Title: **Stage 1 Road Safety Audit**

**Proposed Strategic Housing Development, Greenpark
Housing.**

Client: **PUNCH**

Report reference: **1153R01**

Drawing 191325- PUNCH-XX-XX-DR-C-0450 Rev PLO, Link Road.

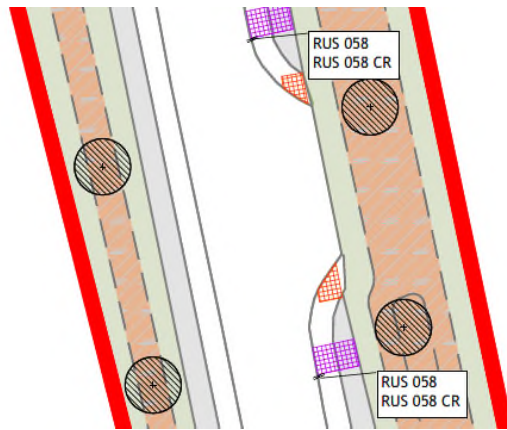
The footpath and cycle track merge into a single shared use crossing point at the potential future access on the Link Road southbound between the Greenpark Roundabout and the Greyhound stadium roundabout. This could lead to collisions between cyclists and pedestrians as they have to share a narrow space.

It is recommended that the cycle track be brought on-road across the junction without a shared area for pedestrians.

Drawing 191325- PUNCH-XX-XX-DR-C-0450 Rev PLO, Link Road.

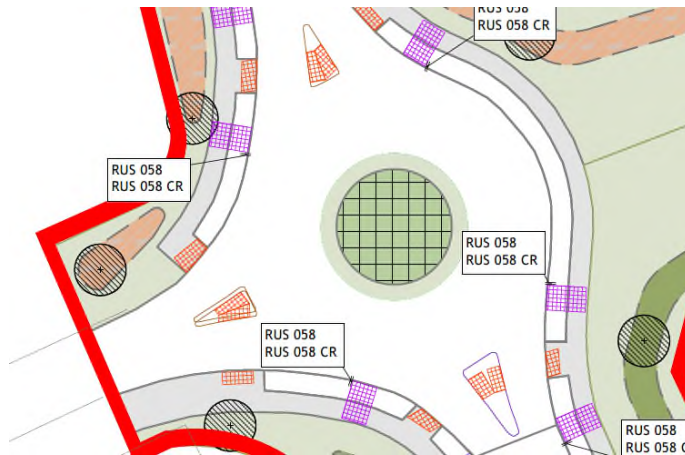
Two of the splitter islands at the greyhound stadium roundabout appear to be too small to be able to provide safe refuge for cyclists and pedestrians. If the islands are not wide enough, pedestrians with bicycles or those pushing buggies may be struck by passing vehicles.

It is recommended that the traffic islands be made sufficiently large to cater for vulnerable road users.

Drawing 191325- PUNCH-XX-XX-DR-C-0451 Rev PL0, Link Road.

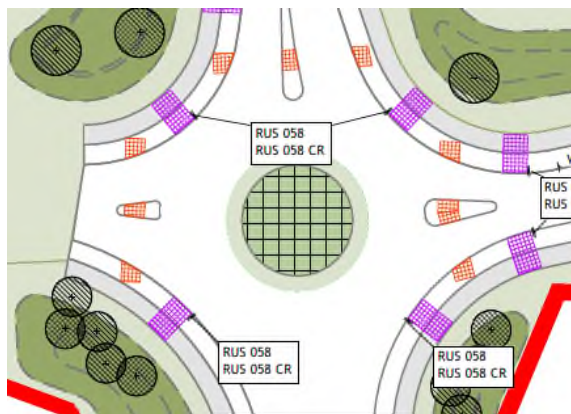
The splitter islands at the proposed new roundabout appear to be too small to be able to provide safe refuge for cyclists and pedestrians. If the islands are not wide enough, pedestrians with bicycles or those pushing buggies may be struck by passing vehicles.

It is recommended that the splitter islands be made sufficiently large to cater for vulnerable road users.

Drawing 191325- PUNCH-XX-XX-DR-C-0451 Rev PL0, Development Access from Link Road.

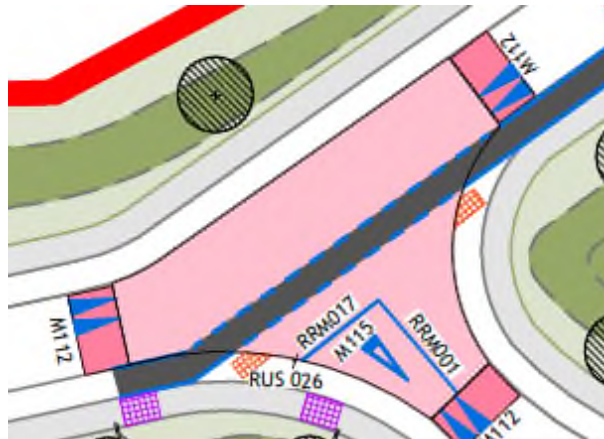
The corner radii at the junction into the proposed residential area are high. This could lead to high turning speeds and possible collisions with pedestrians and cyclists. It is also proposed to provide a yield control which would also lead to higher turning speeds.

It is recommended that tighter corner radii are provided in accordance with the guidance in DMURS and that a stop control is provided.

Drawing 191325- PUNCH-XX-XX-DR-C-0451 Rev PL0, cycle track provision in residential area.

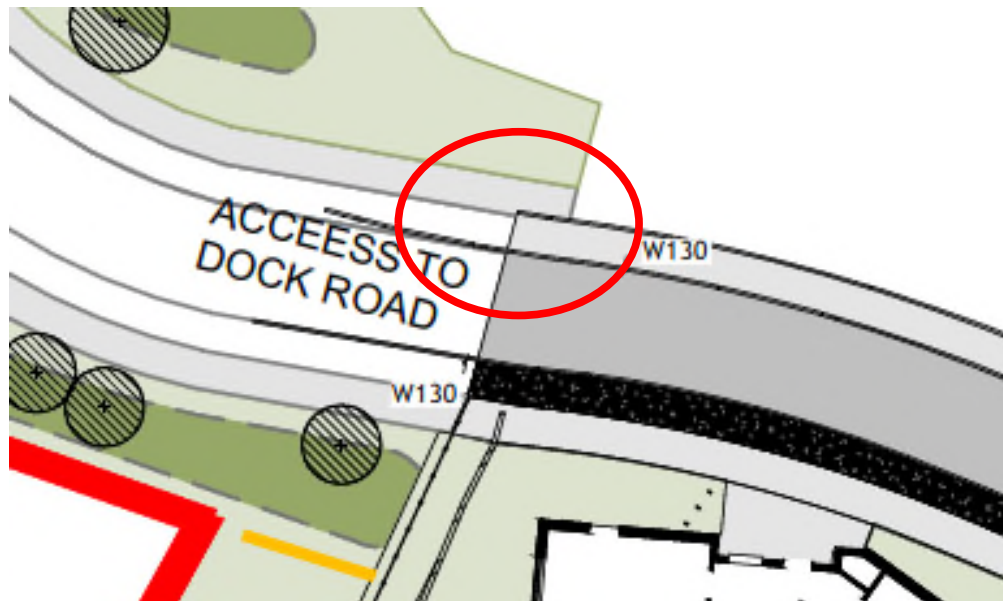
There is a change in cross section at the main access road outside the creche. The cycle track terminates suddenly. This could lead to cyclists sharing the footpath with pedestrians which may lead to collisions between those two user groups due to a lack of space for both.

It is recommended that a consistent cross section to be provided along the main access road.

Drawing 191325- PUNCH-XX-XX-DR-C-0452 Rev PL0, throughout the scheme, yield control junctions.

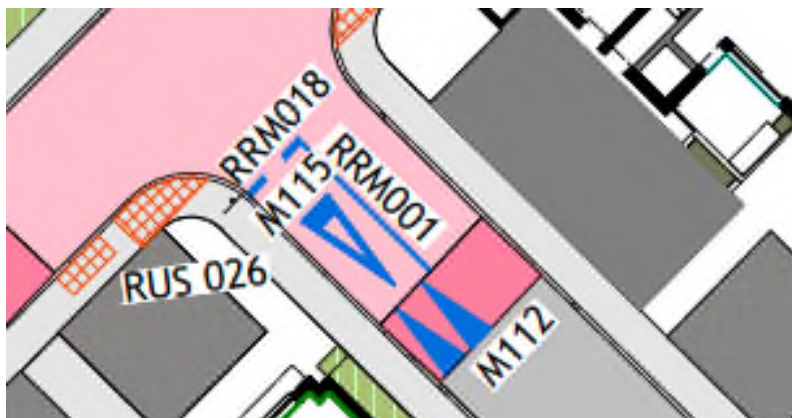
It is proposed to provide yield control junctions throughout the scheme. This could lead to higher turning speeds and in turn higher injury severity if vulnerable road users are struck.

It is recommended that stop control be provided in lieu of yield control.

Drawing 191325- PUNCH-XX-XX-DR-C-0452 Rev PLO, The Paddocks.

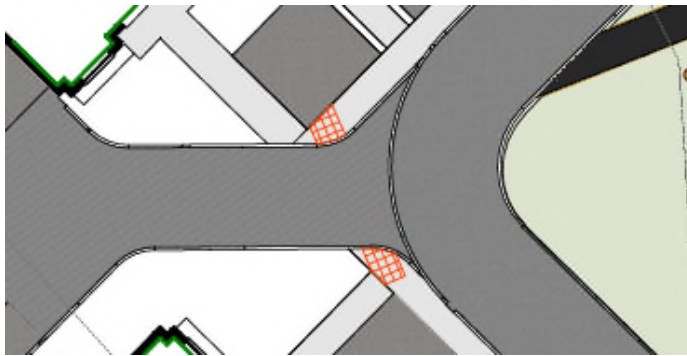
It is proposed to provide vehicle access to 2 no. residential units at five of the corners of The Paddocks. At these accesses points the footpath is to be terminated and dropped kerbs and tactile paving provided. This gives priority to vehicular traffic which would be infrequent. It is anticipated that this area will be used regularly by children playing. Drivers may not anticipate pedestrians to cross and this may lead to a higher likelihood of a collision.

It is recommended that pedestrians be given priority and that the footpaths be made continuous with drivers having to stop and check for crossing pedestrians.

Drawing 191325- PUNCH-XX-XX-DR-C-0452 Rev PL0, General Item, uncontrolled crossing areas.

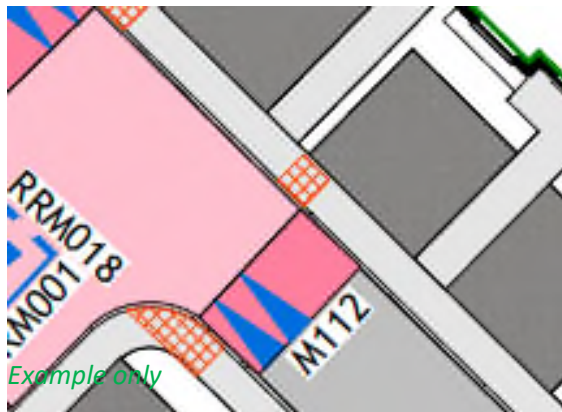
There are uncontrolled pedestrian crossings at each of the raised tables at internal junctions within the development. At some locations the uncontrolled crossings are where vehicles will be reversing out of curtilage parking spaces. This may lead to collisions with small children who attempt to cross at the crossing point and vehicles whose drivers cannot see them in their mirrors. In addition, the tactile paving may not be capable of taking vehicular loading and may crack in time leading to trip hazards for pedestrians.

It is recommended that the crossing points be away from area where drivers will be reversing.

Drawing 191325- PUNCH-XX-XX-DR-C-0750 Rev PLO, J10 Sightlines.

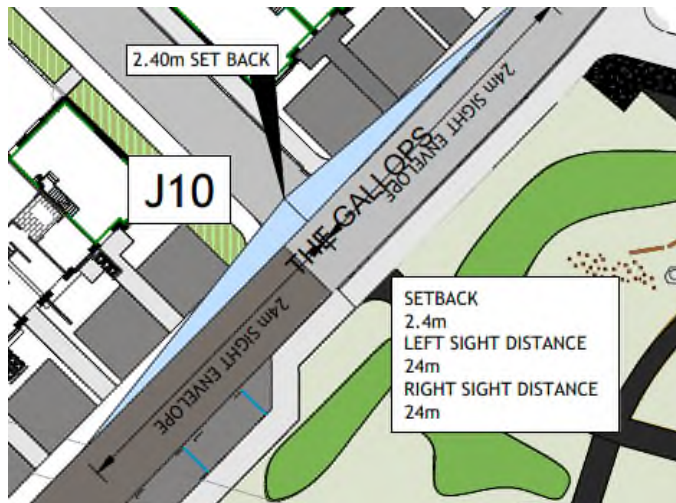
The visibility envelope at J10 intersects with the curtilage parking spaces for the residential unit to the left. This could lead to a lack of visibility for exiting drivers if the parking spaces are occupied by high vehicles such as vans or hatchback SUVs.

It is recommended that the visibility envelope be kept clear of obstructions.

Drawing20133-RAU-ZZ-ZZ-DR-A-02.1004 Rev A

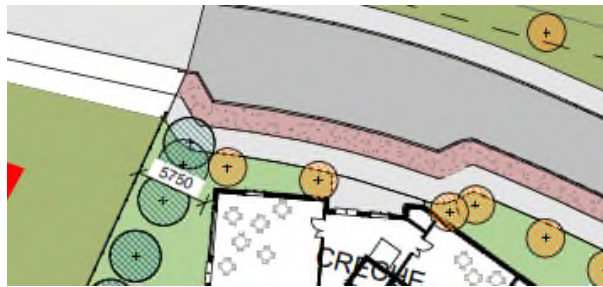
This drawing shows a set down area outside the creche. The set down area is along the cycle track. There could be collisions between cyclists and opening doors from parked cars.

It is recommended that a shared area be provided along the set down and that a buffer zone be provided between the parked cars and the shared use area.
